Consideration of a Preliminary Plat for the Whiting Cove Plat "E" and "F" Subdivision consisting of 17 lots located at 1050 South Highway 89.

WHITING COVE PLAT "E"
A SINGLE FAMILY DEVELOPMENT
ATLAS ENGINEERING
L.L.C.

Development Review Committee Minutes

May 3, 2021

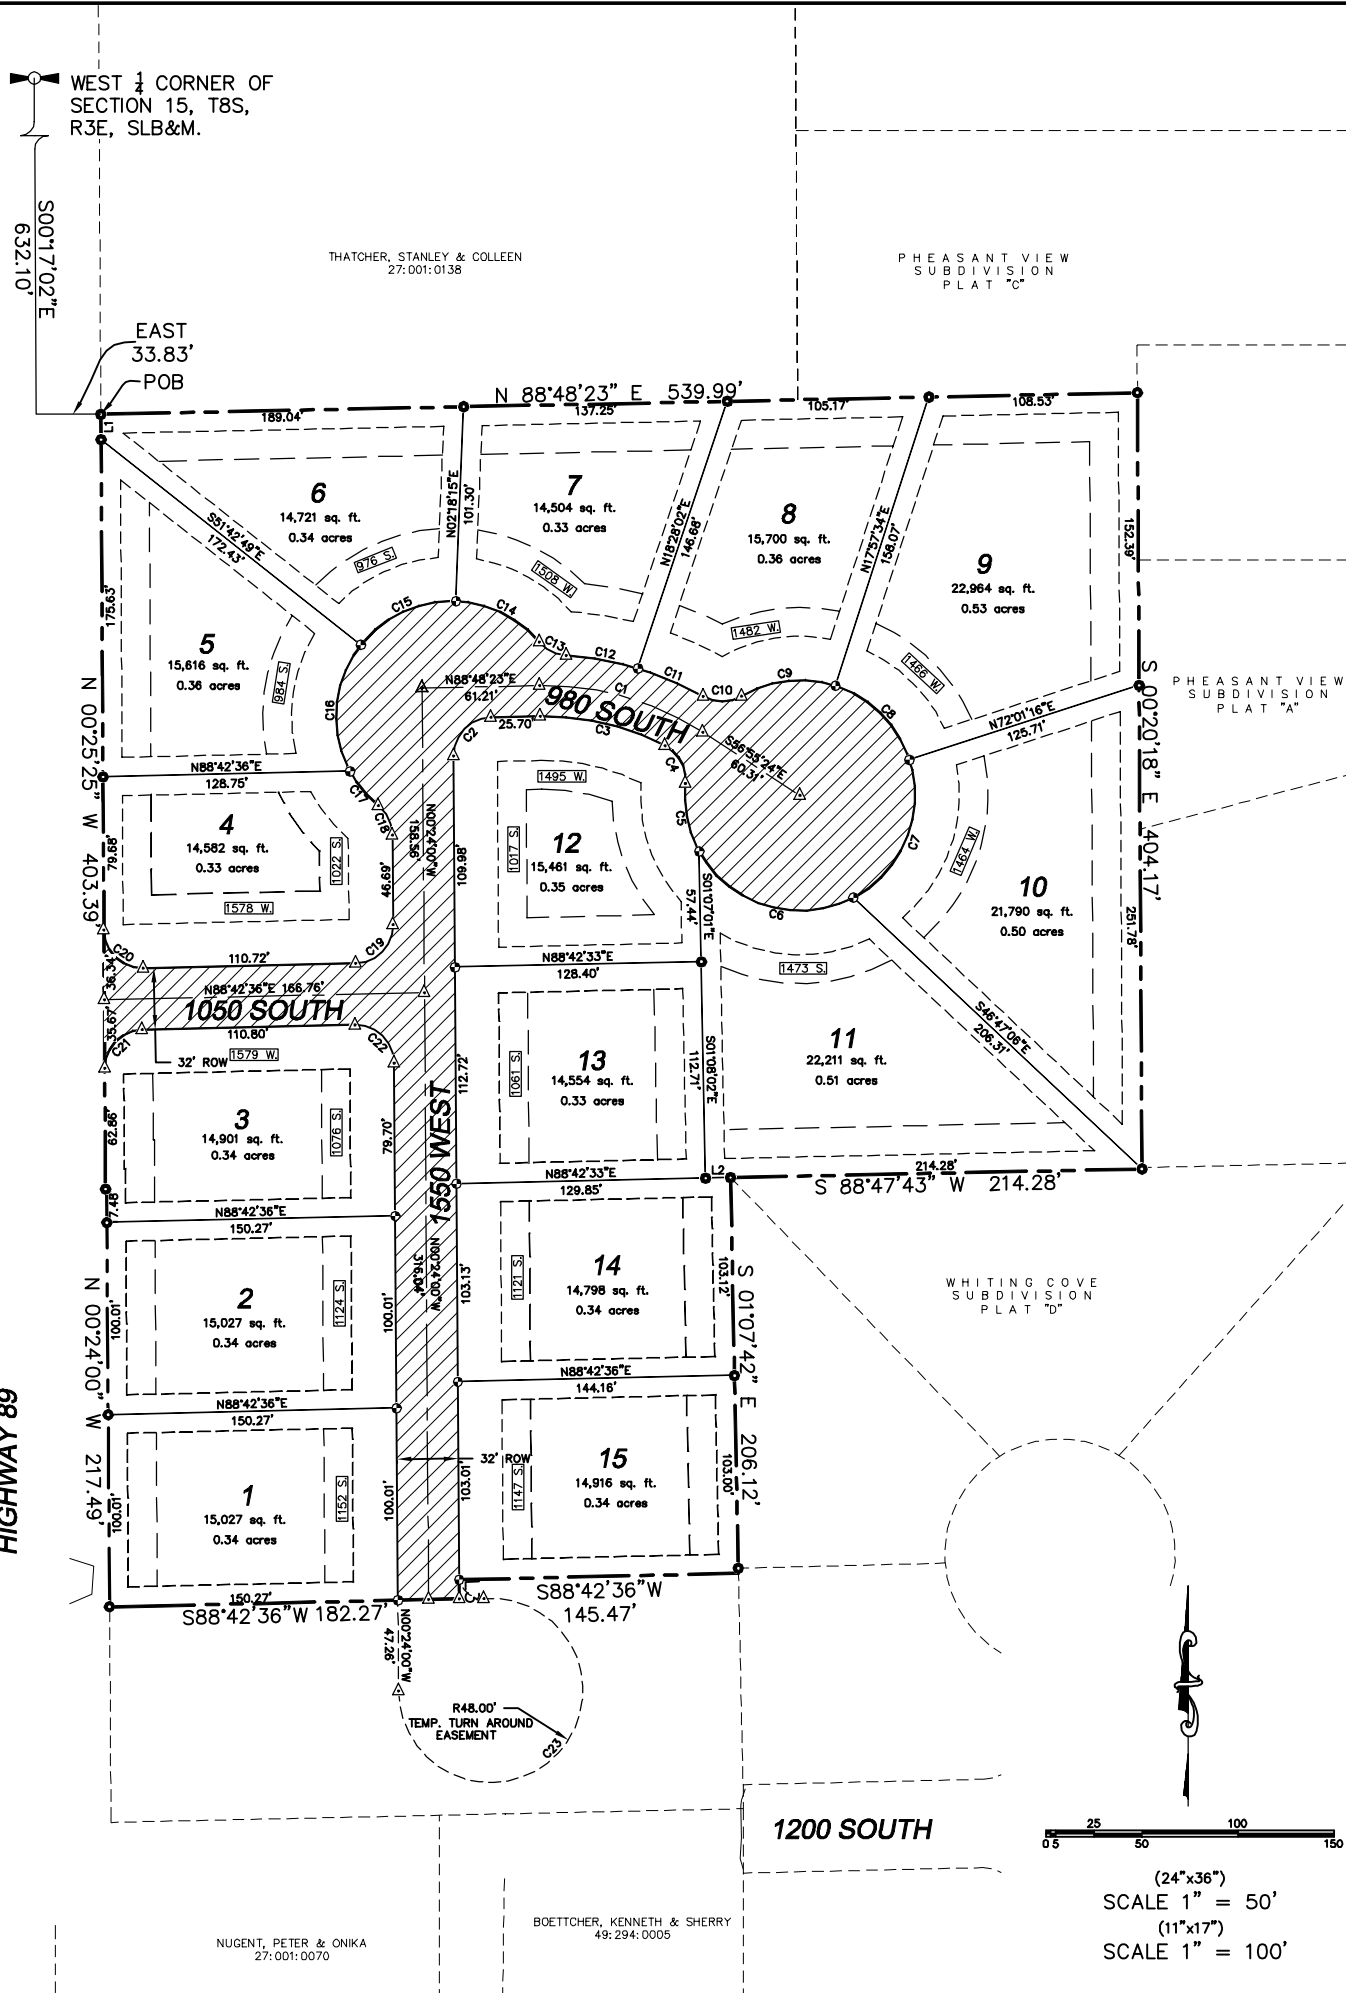
1. Highway 89 frontage to include (please show on plans):

- Masonry wall along property line
- 10' asphalt trail
- Planter strip between curb and trail to include 1 London Plane Sycamore tree for every 35' of frontage and one street light every 150'. City to provide street light spec.

2. Is lot 11 being combined with the lot 3 of plat "D"? If so, please show that on the plat with the note under the title "including a vacation of lot 3 of Whiting Cove Plat "D". Also, lot 11 must still include the planter strip and sidewalk.

1. Submit Geotech report
2. Submit culinary water analysis performed by RB&G Engineering
3. Create sheet showing improvements along the highway

1. A UDOT Access permit will be required for 1050 S and 1200 S
2. Add street sign to 980 South and 1550 West
3. Add streetlight to intersection with highway 89 and inside corner of bulb out on 980 S
4. Highway 89 road section needs to include a 10' asphalt trail with 8' park strip

1. Move PI Main in US 89 to the park strip and upsize to 12" per the city master plan
2. Move blow off to the park strip
3. Lot 12 is missing a PI service
4. Is the plan to loop the PI to the other Whiting Cove phases to provide live PI now?

1. Verify location of culinary water in HWY 89
2. Move blowoff to the park strip
3. Add Fire Hydrant to south end of the line on 1550 West

1. Please submit power plans for fiber design
2. Conduit and services will need to be installed for future city fiber
